Office Action Summary

10/673,053

BRUCHHAUS ET AL.

DETAILED ACTION

FIG. 18

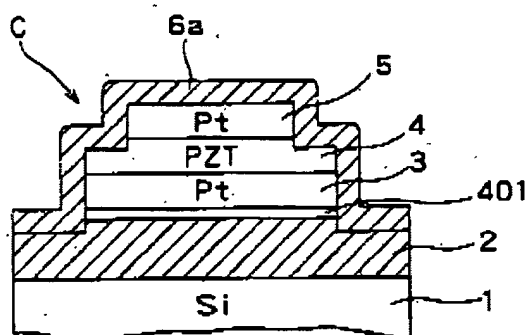
Kanaya discloses a method of forming a ferroelectric capacitor comprising forming a crystalline PZT layer as claimed. **See all the FIGS** where Kanaya teaches the following limitations

1. Pertaining to claim1, Kanaya discloses a method of forming a ferroelectric capacitor comprising forming a crystalline PZT layer by a process including the steps of:

depositing a layer of amorphous ferroelectric material **4** over a layer of a first material **3**;

etching the ferroelectric layer to form isolated ferroelectric elements (**See Fig 1 & 2, column 1 Paragraph [0018] ,please note briefly explain about etching process) ;**

providing a layer of a second material **5 & 6** on at least the side surfaces of the ferroelectric elements; and

performing an annealing step to crystallize the ferroelectric material (**Column 7 Paragraph [0129] Lines 4–7**);

the second material **5 & 6** promoting crystallization of the ferroelectric material to a higher degree than the first material **3**;

whereby the crystallization proceeds horizontally through the ferroelectric elements (

Please note thermal annealing process initiates to form a crystallization on ferroelectric material) .
